G-05501-R2
May 2005

SUBJECT: SAFETY RECALL (U.S., EXPORT)
FRONT DRIVE SHAFT on 4800 4x4's with FABCO
TC-200 TRANSFER CASES built 6/30/1999 thru
5/8/2002

This Recall is the final remedy and supersedes Safety Recall G-03516

Date Code Location

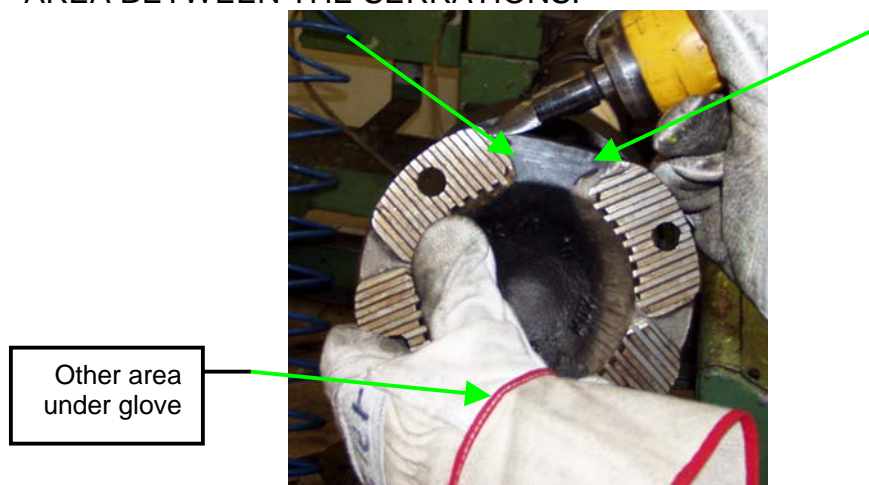
- Locate label and date code on new drive shaft.

- Date code format is as follows: DAY.MONTH.YEAR. The example above corresponds to October, 6th, 2005.
- If date code is between **01.06.04** and **11.10.04** (*June 1st, 2004 thru October 11th 2004*), perform the following inspection on the shaft's companion flanges.
- If the date code is after 11.10.04, continue on to **FRONT DRIVESHAFT REPLACEMENT**.
- Inspect the serrations in BOTH flanges for excess material in the FLAT AREA BETWEEN THE SERRATIONS.
